Town of Rolesville, NC
Department of Planning

Comments on #SDP-26-0008 - Planning & Zoning: Site Development Plan

Application Number: #SDP-26-0008
Application Type: Site Development Plan
Date: July 24, 2026
Address: 408 E YOUNG ST, ROLESVILLE, NC 27571
Parcel: 1768098727

SHEET NUMBER:
C-3.01

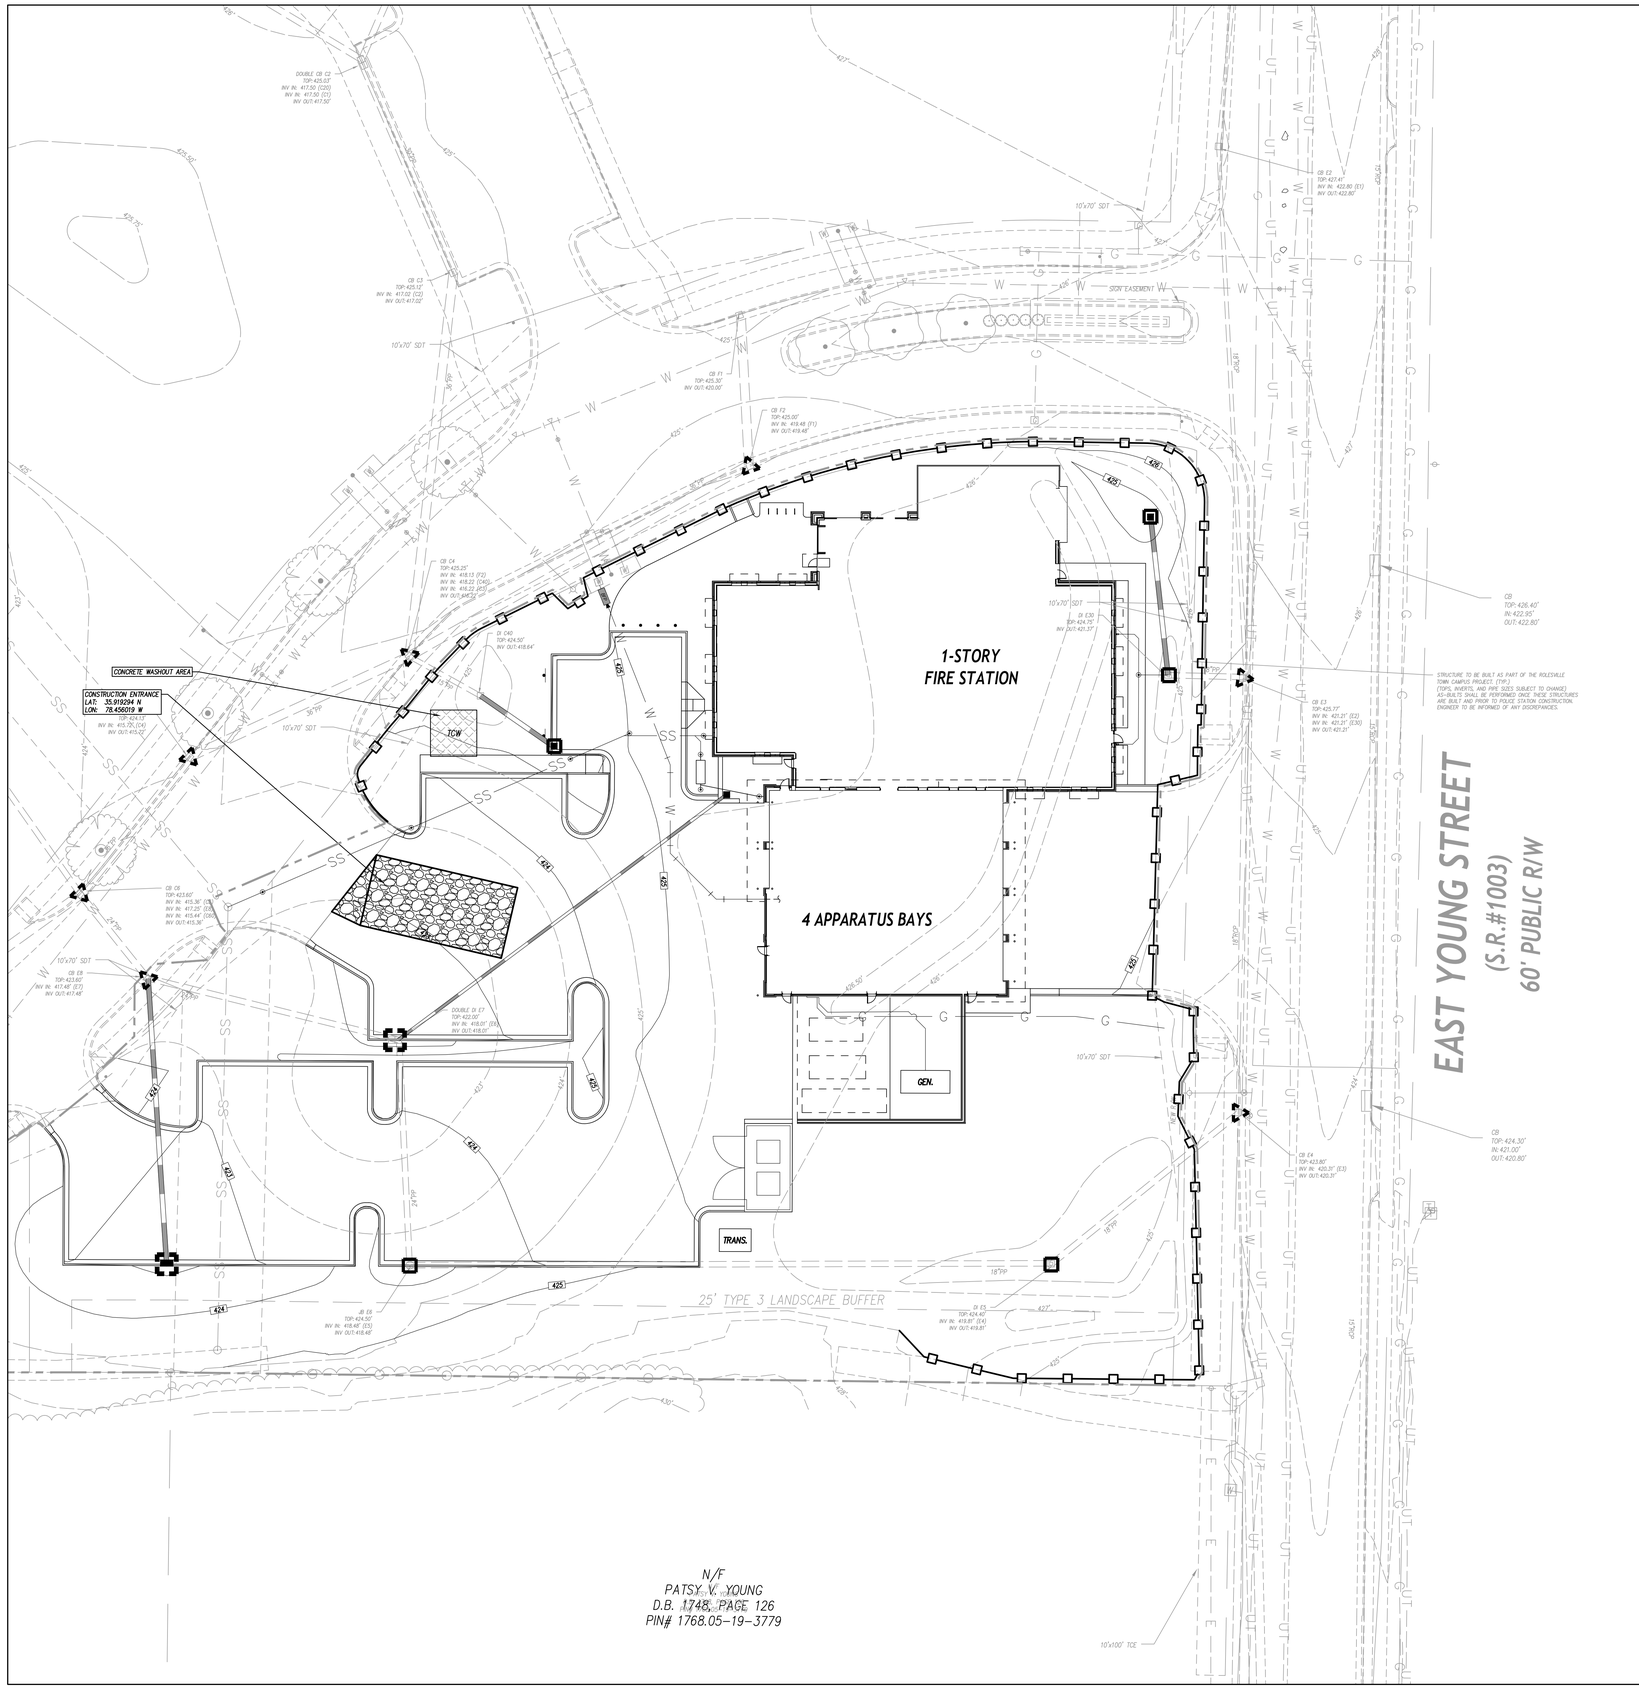
25 **Jacqueline Thompson**
Please confirm if this existing storm is public or private and if it will have an easement.

26 **Jacqueline Thompson**
Please include scale and north arrow.

SHEET NUMBER:
C-4.01

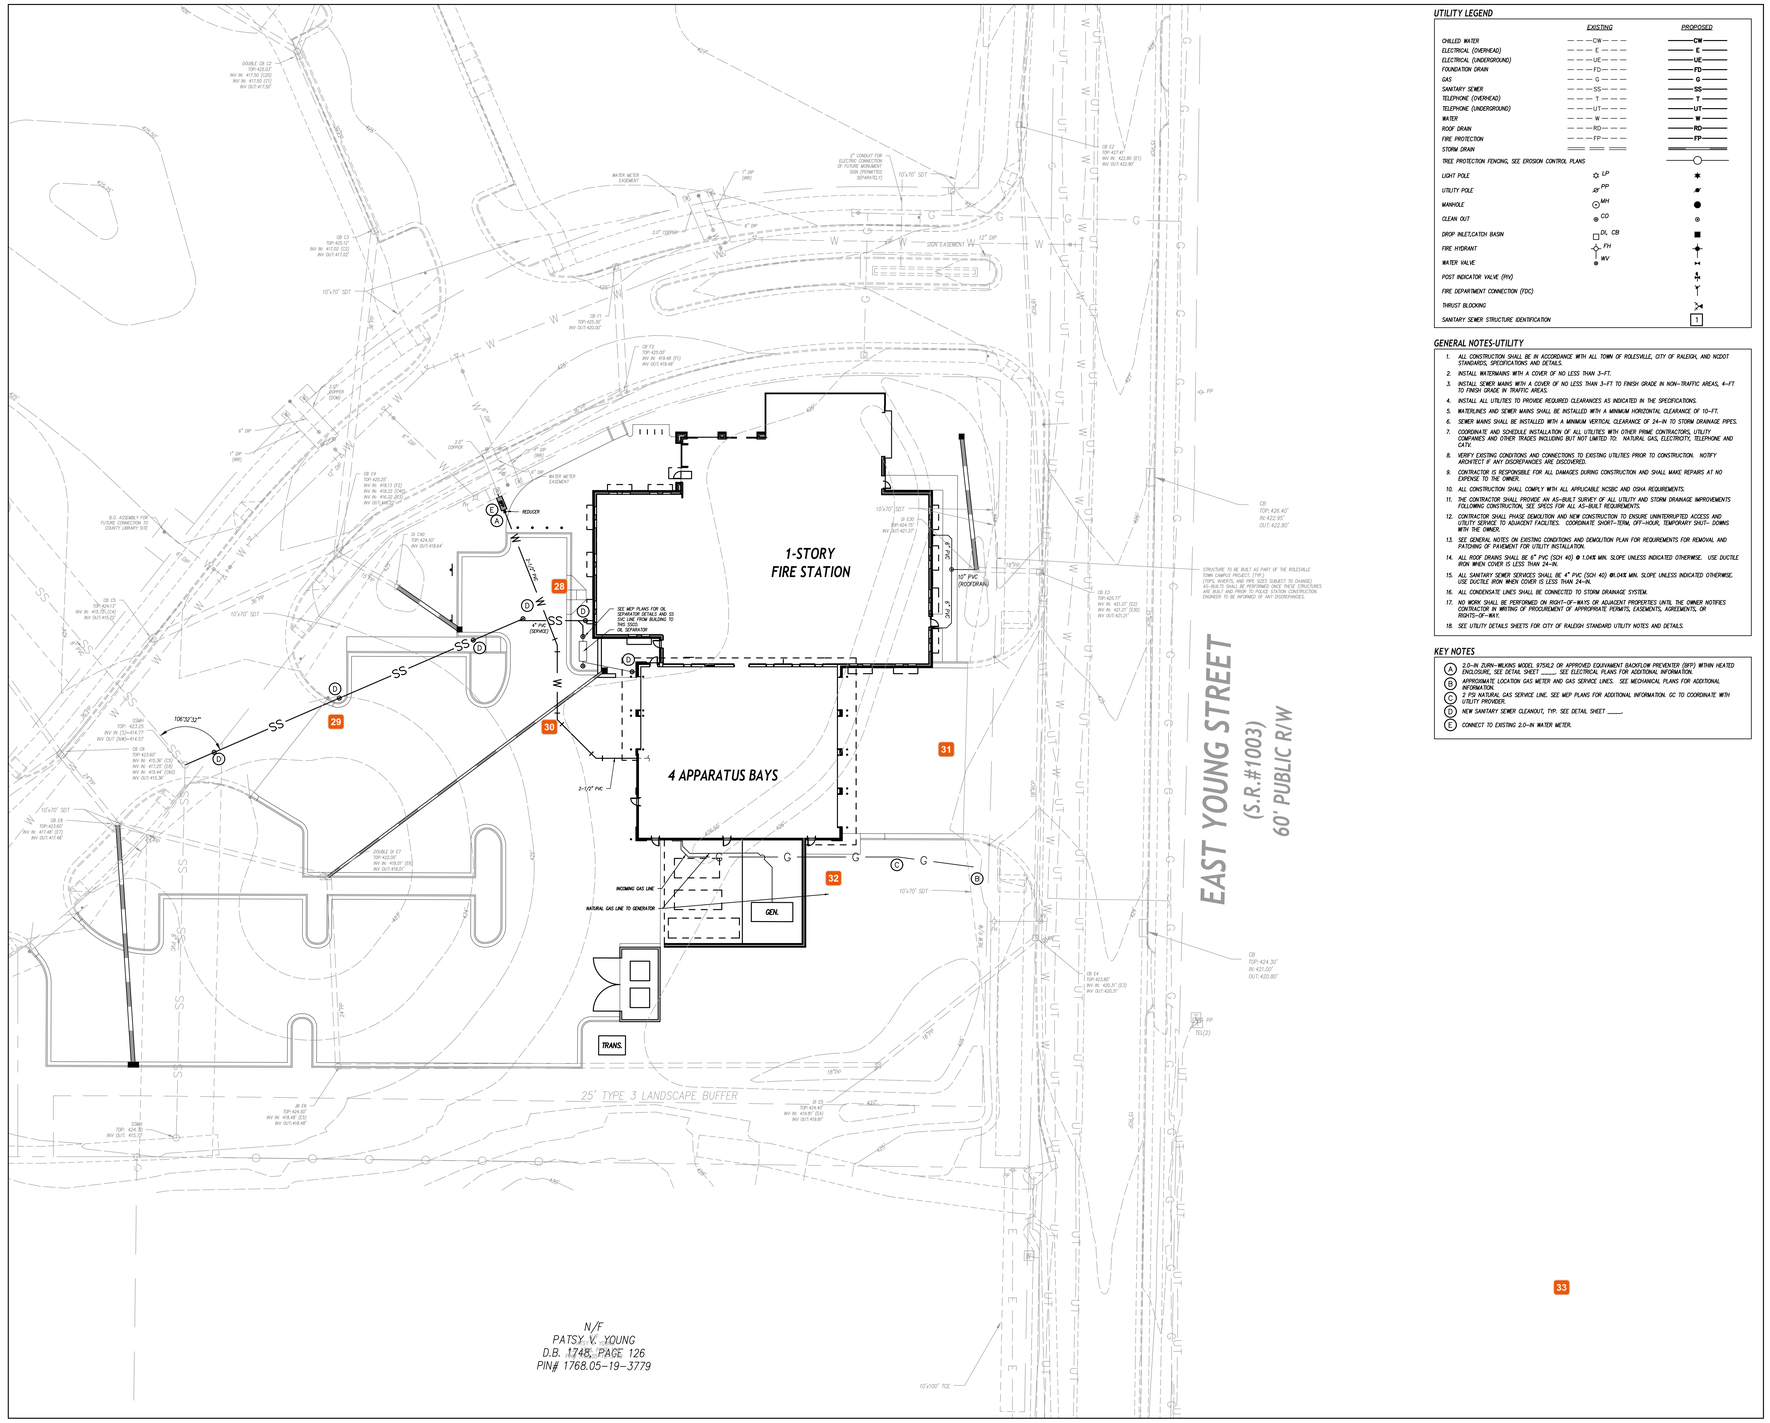
27 **Jacqueline Thompson**
Please include north arrow and scale.

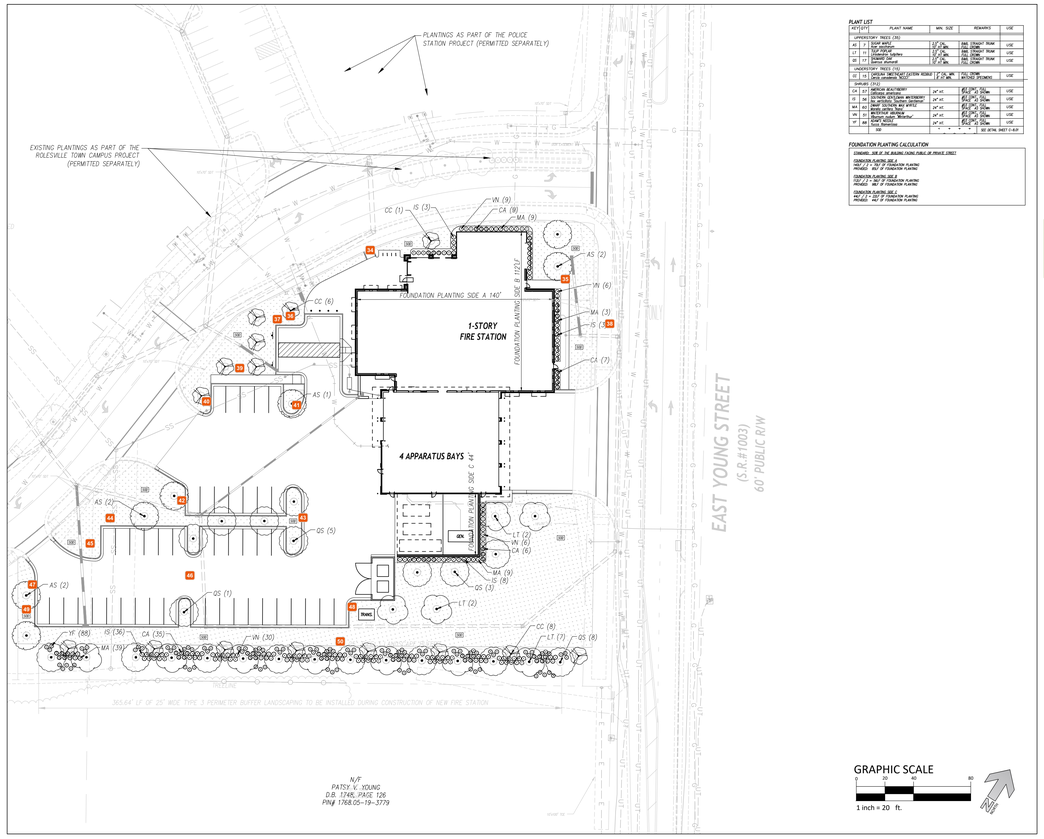
32 Jacqueline Thompson
Leader is not pointing to anything. Please review and adjust

33 Jacqueline Thompson
Please include a scale and north arrow

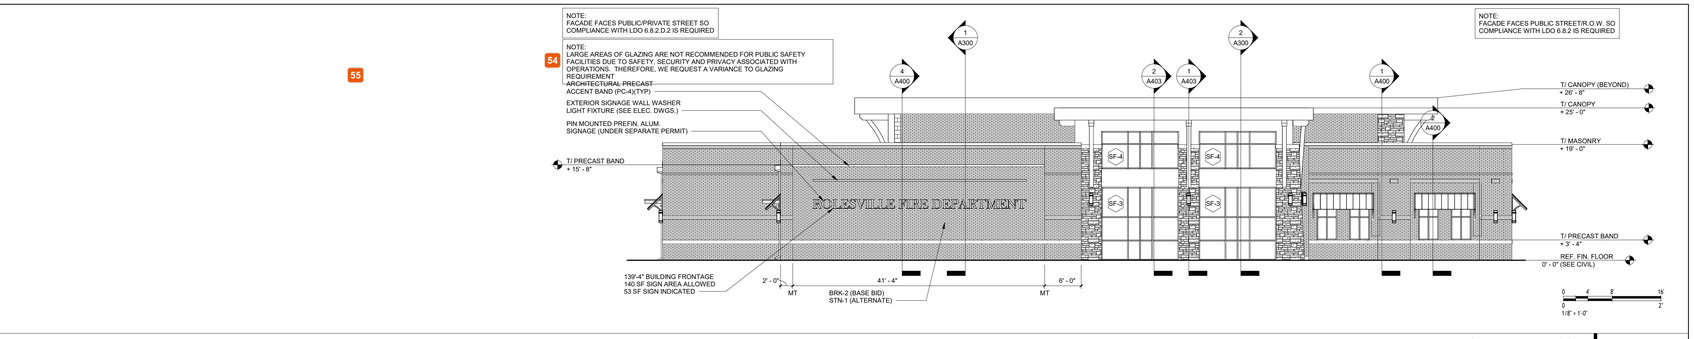
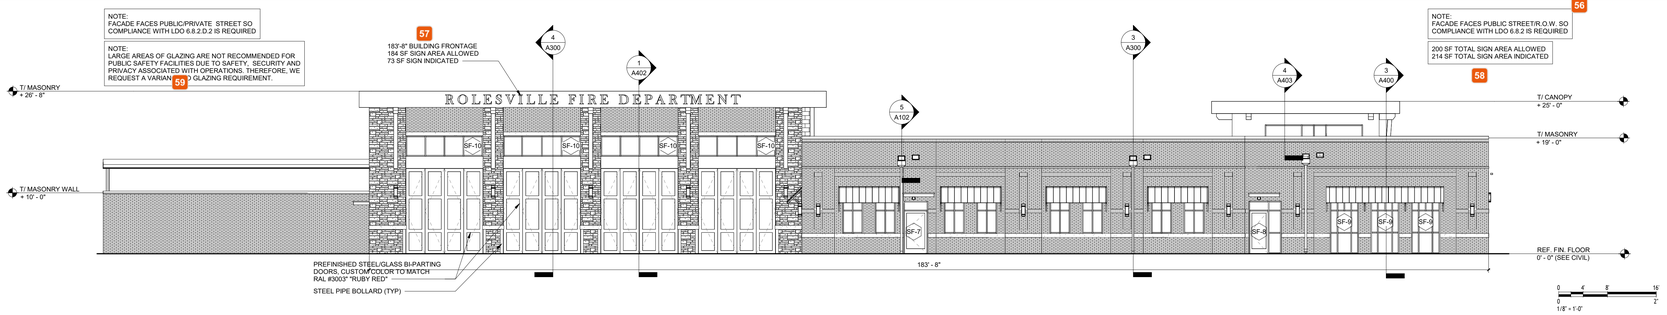
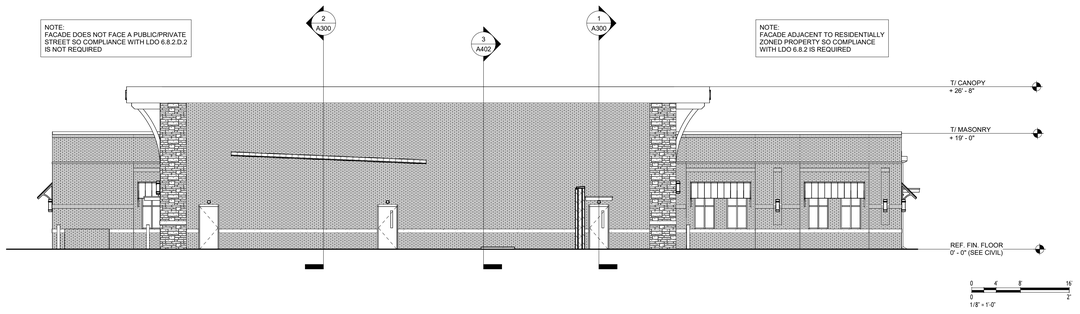
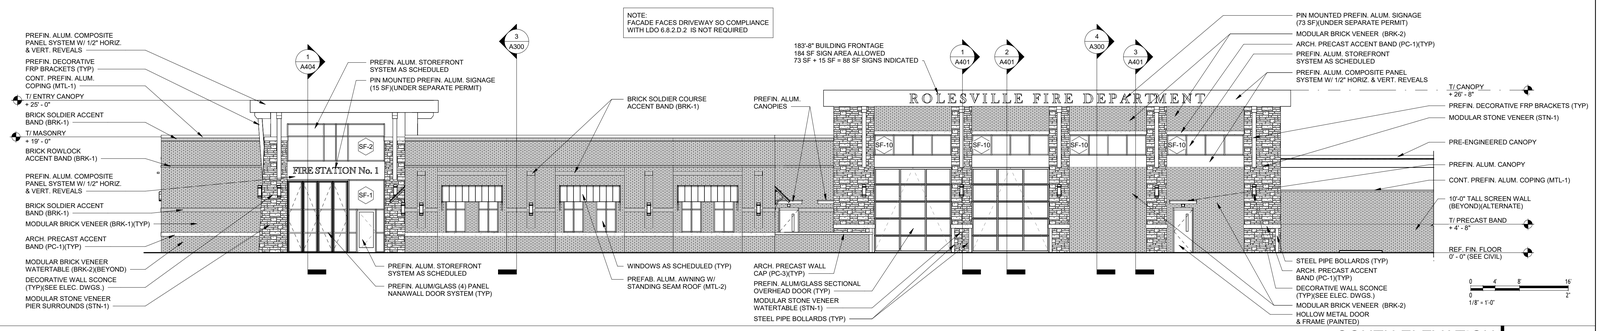
52 **Stephen Wensman**
This note should be on the landscape plans.

53 **Stephen Wensman**
See updated buffer requirements and add 75% opacity requirement to this note

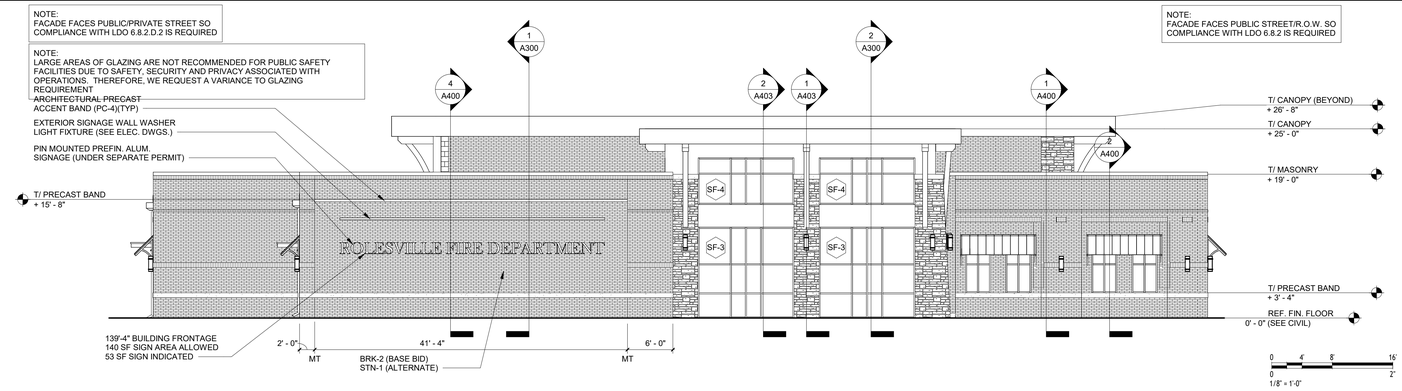
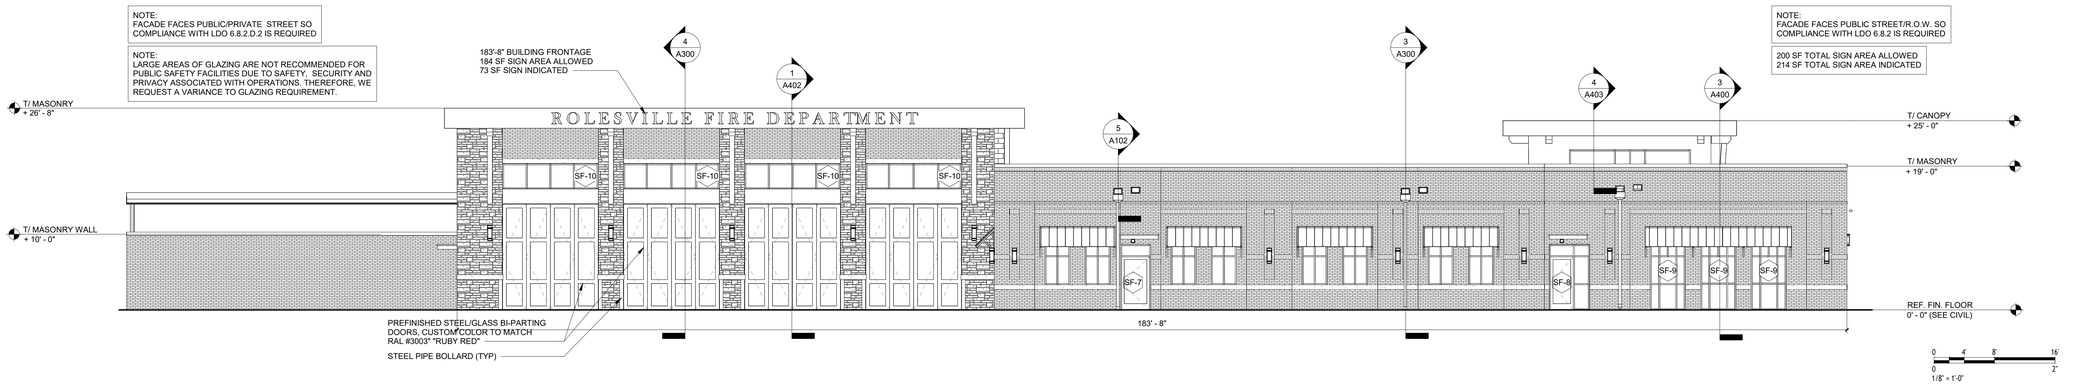
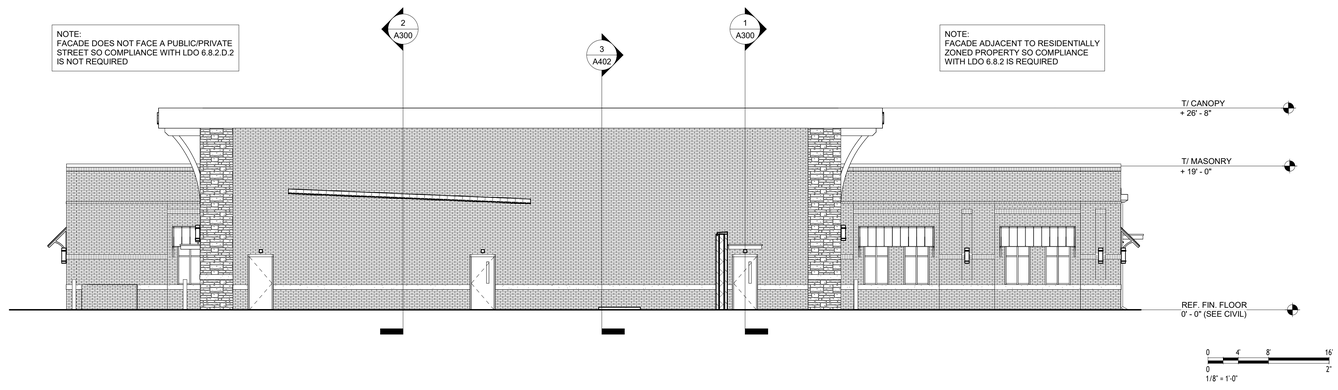
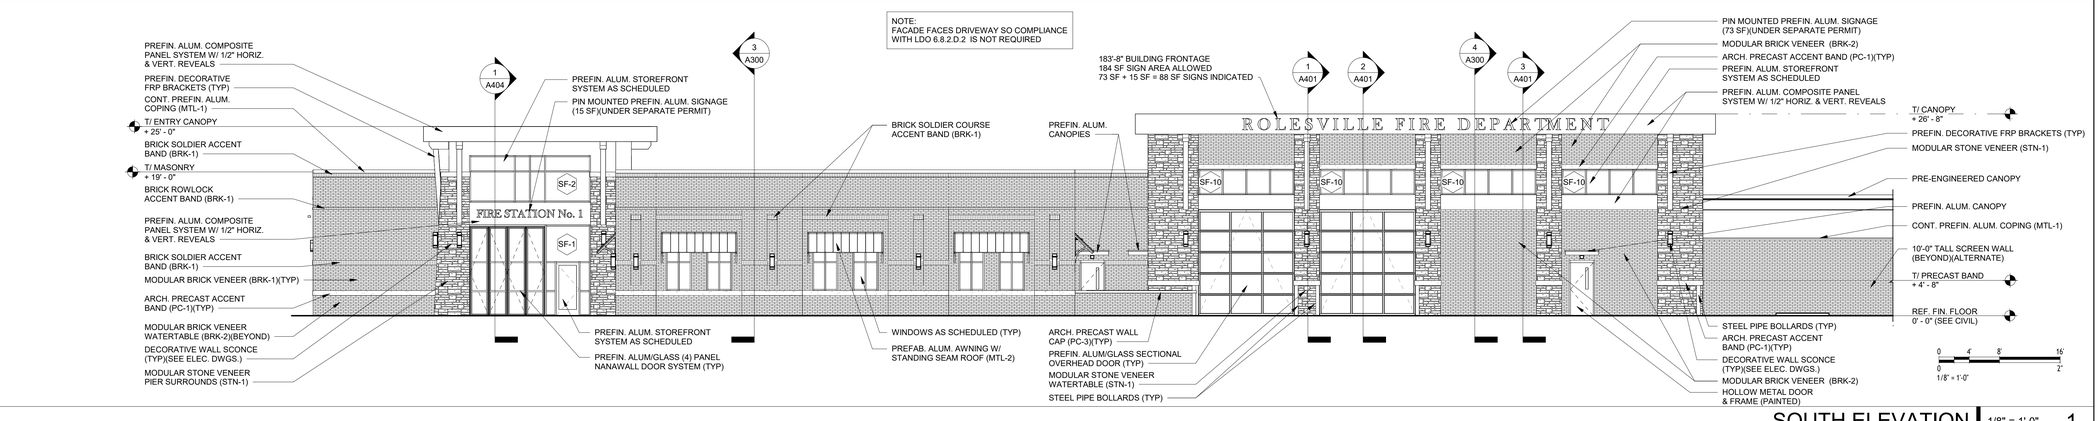
58 Michael Elabarger
While no SIGNAGE is reviewed or approved (permitted) via this Site Development Plan - the numbers indicated do NOT equate to compliance - if the maximum sign area is 200SF, you can't propose 214 SF - that is Not In Compliance.

59 Michael Elabarger
See Previous Comment about Public Safety uses being exempt from Transparency - remove this note altogether.
